Intel[®] Mobile Celeron[™] Processor at 466 MHz, 433 MHz, 400 MHz, 366 MHz, 333 MHz, 300 MHz, and 266 MHz Specification Update

Release Date: October 2000

Order Number: 244444-019

Figure 2. Workaround Flowchart: SMBALERT#-Driven System

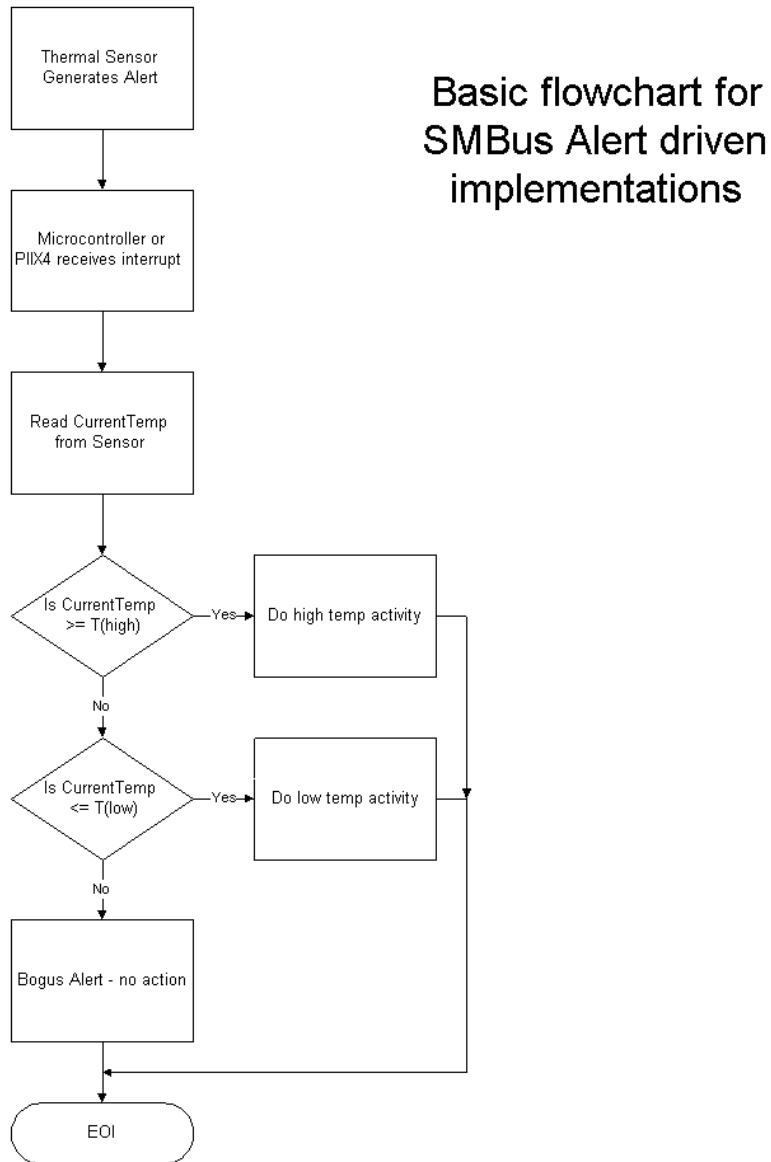
H29. Thermal Sensor May Assert SMBALERT# Incorrectly

Problem: The Intel Celeron Processor Mobile Module has a thermal sensor that monitors the processor core's temperature. Please note that desktop systems could have a similar thermal device. The thermal sensor asserts SMBALERT# if the processor temperature exceeds the temperature limits set in the Alarm Threshold Registers (T_{HIGH} , T_{LOW}). It also sets the corresponding Status Register bits to identify the cause of the interrupt. Figure 1 gives one example of the how the SMBALERT# signal could be used in a system.

Workaround: Three different (mutually exclusive) workarounds are possible:

1. Before servicing an interrupt from the thermal sensor, read and compare the processor thermal reading with the threshold limits (T_{HIGH} or T_{LOW}). Figures 2 and 3 provide basic flowcharts for the implementation of this workaround in an interrupt driven system.
2. If the firmware implemented polls the Status Register only, then before taking any action, re-read the temperature register and do a comparison with the alarm threshold limits (T_{HIGH} or T_{LOW}) to determine if the value is actually still within the temperature window.
3. Use a temperature polling scheme to monitor the processor temperature.

Figure 5.3. Surface-Mount BGA1 Package—Top and Side View

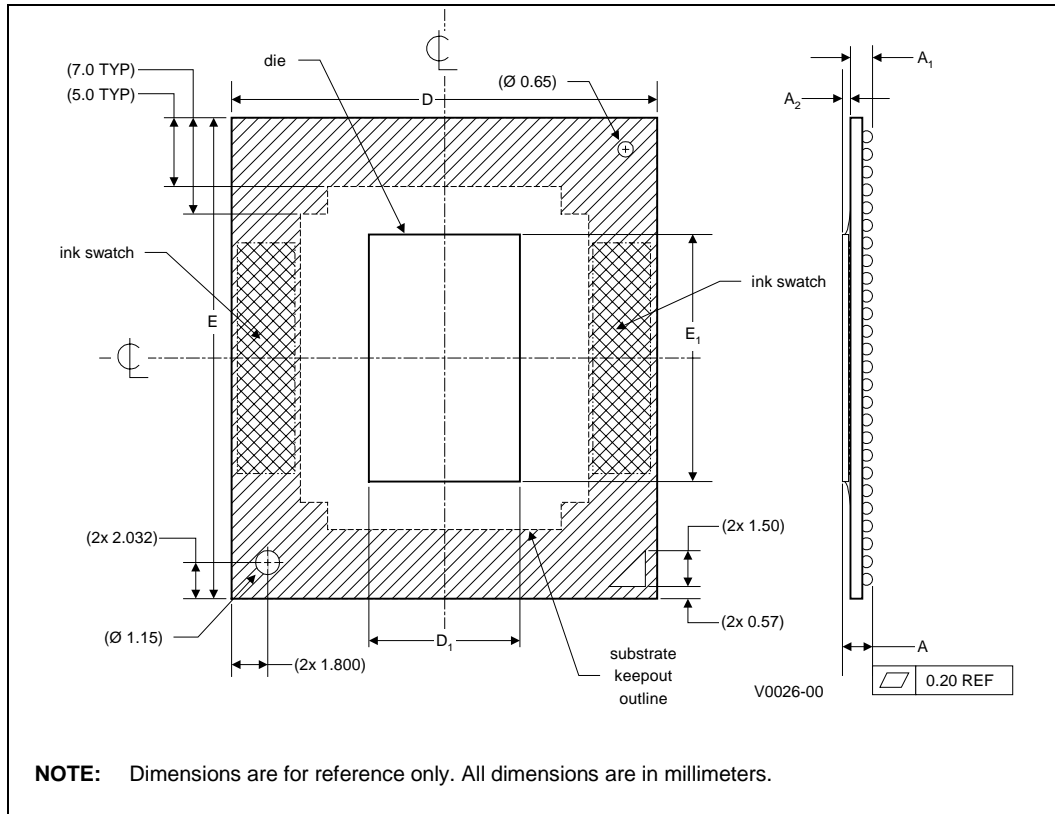
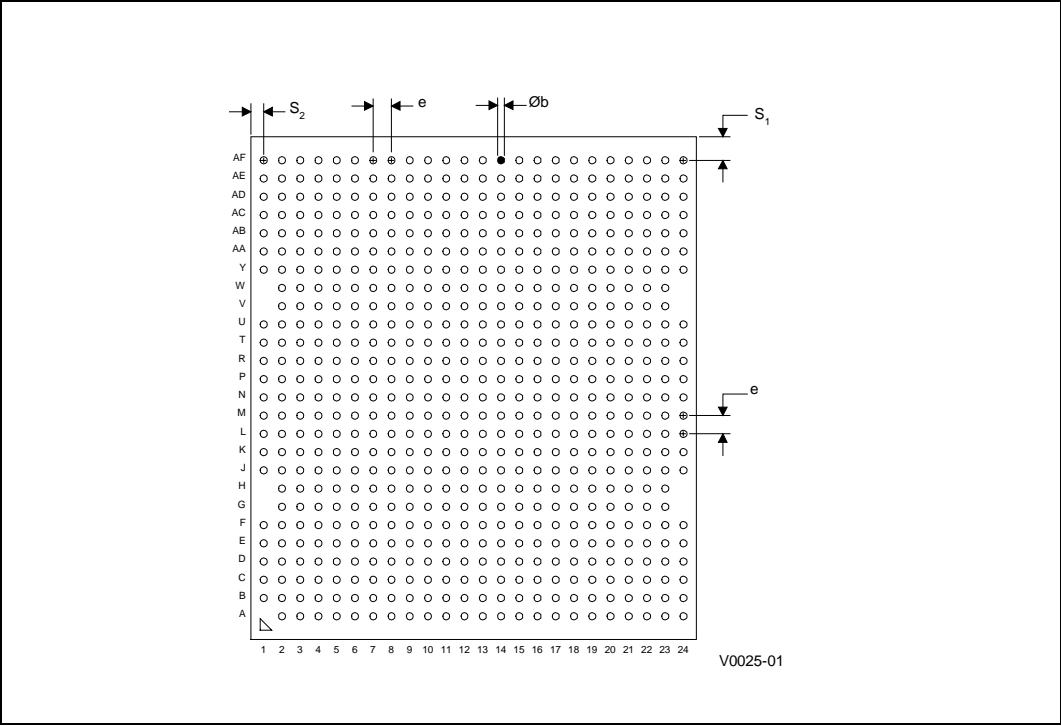
The following table and figures show the updated mechanical specifications for the BGA1 package, listed as Table 5.2, Figure 5.3 and 5.4, respectively, in the *Intel® Mobile Celeron™ Processor in BGA Package at 333 MHz, 300 MHz and 266 MHz* datasheet.

1. The number shown here is different from that in the 244444-004 version of this specification update. The maximum reference number is used.

Figure 3.3 Generic Clock Waveform

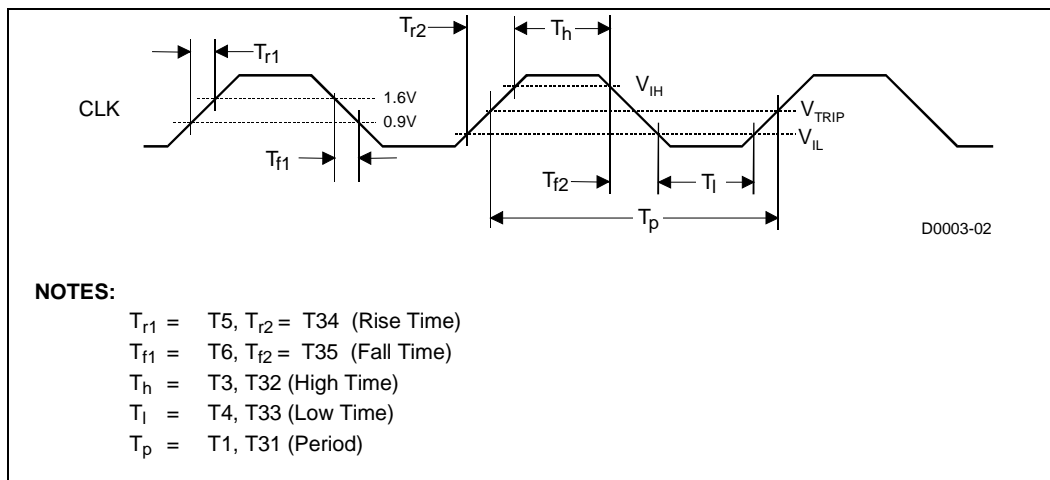
H11. Generic Clock Waveform Figure

Figure 3.3 in the *Intel® Mobile Celeron™ Processor in μPGA1 and BGA1 Packages at 366 MHz, 333 MHz, 300 MHz, and 266 MHz* datasheet (Order Number 245112-003) has been updated. The following figure is to replace the one in the above document.
